Project	IEEE 802.16 Broadband Wireless Access Working Group < http://ieee802.org/16 >
Title	Correction of Figure D.8
Date Submitted	2006-09-23
Source(s)	Yerang Hur yehur@posdata-usa.com POSDATA Co., Ltd.
Re:	Call for Maintenance Change Requests on IEEE Std 802.16
Abstract	This document suggests correcting Figure D.8 in Annex D.2 Sleep Mode MSCs.
Purpose	Adopt change requests on IEEE 802.16e-2005.
Notice	This document has been prepared to assist IEEE 802.16. It is offered as a basis for discussion and is not binding on the contributing individual(s) or organization(s). The material in this document is subject to change in form and content after further study. The contributor(s) reserve(s) the right to add, amend or withdraw material contained herein.
Release	The contributor grants a free, irrevocable license to the IEEE to incorporate material contained in this contribution, and any modifications thereof, in the creation of an IEEE Standards publication; to copyright in the IEEE's name any IEEE Standards publication even though it may include portions of this contribution; and at the IEEE's sole discretion to permit others to reproduce in whole or in part the resulting IEEE Standard

Figure D.8 – Example sleep mode – BS initiated

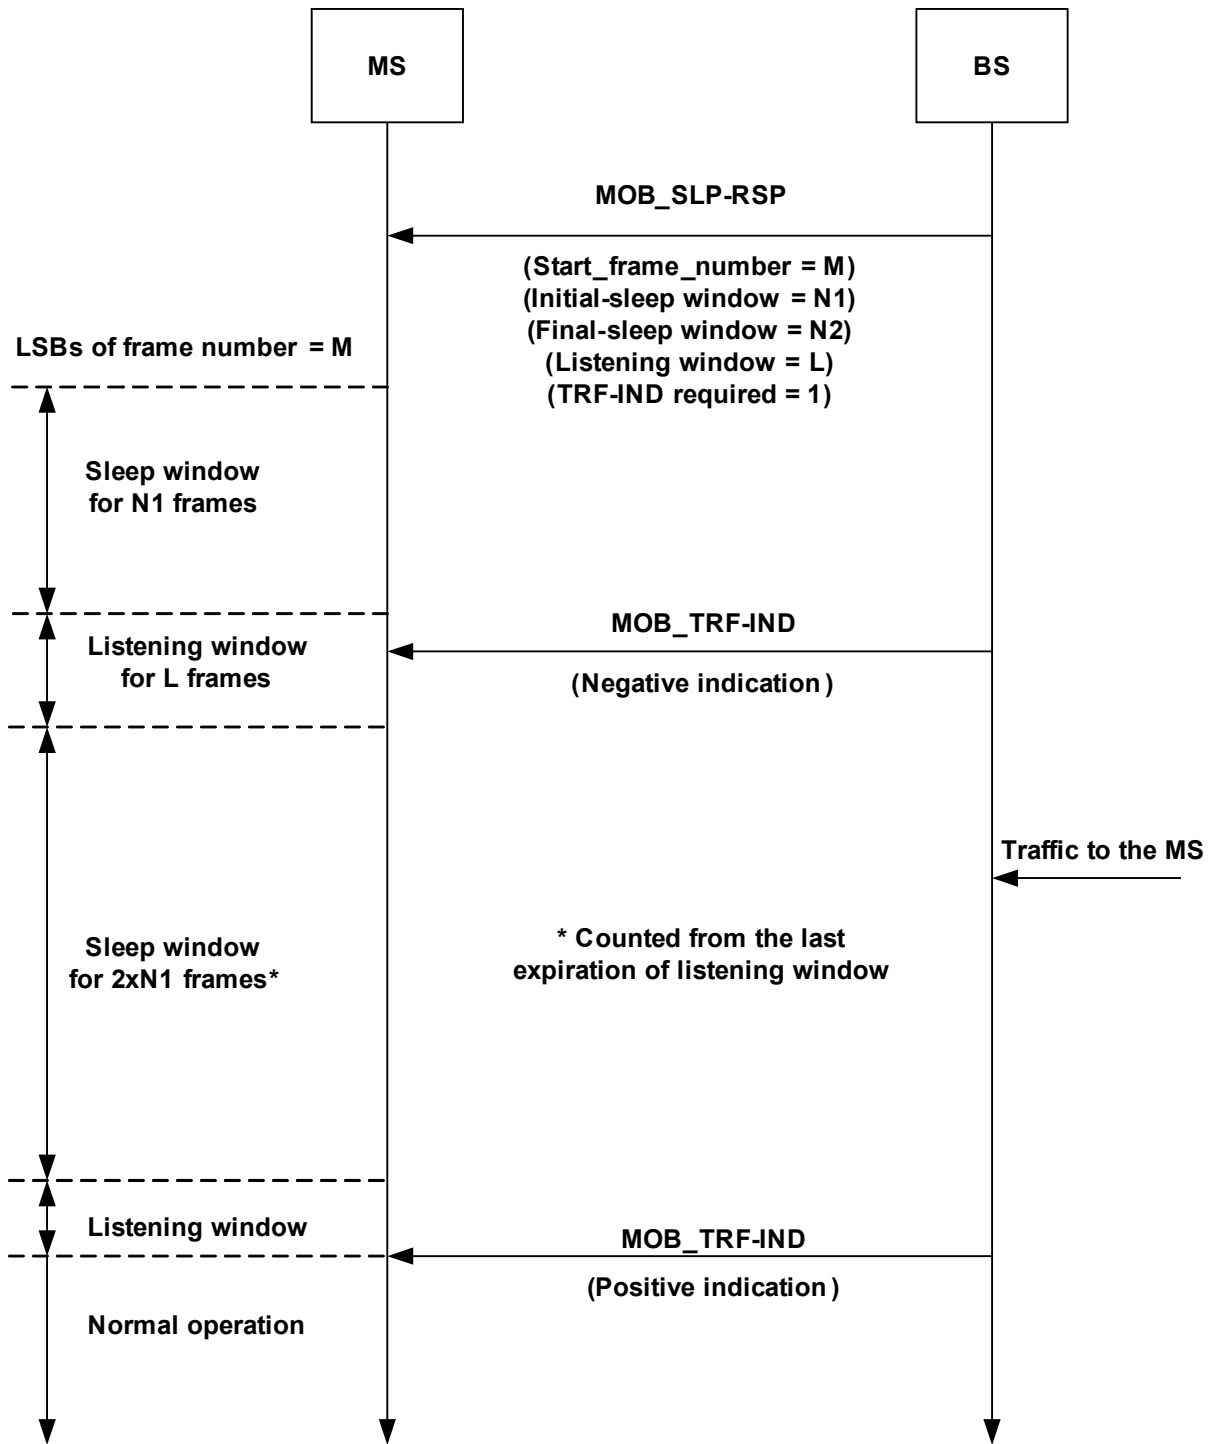
These editorial corrections are required In Figure D.8 of Annex D.2.

- a. Min-sleeping interval and Max-sleeping interval are not defined in sleep mode operation. Those should be Initial-sleep window and Final-sleep window, respectively.
- b. In the left side of the figure start frame of the first sleep window is incorrect. The first sleep window should start at the frame where the LSBs of the frame number is the same as Start frame defined in MOB_SLP-RSP.
- c. The starting arrow of the second sleep window is not consistent with description in 6.3.21.2. The starting arrow of the second sleep window should be aligned with the end of the listening window. Also, the size of sleep window should be counted from the last expiration of listening window according to 6.3.21.2 and Figure 130a. So description on it appearing in the figure should be corrected as well.

[Adopt a revised figure in the next page as Figure D.8:]
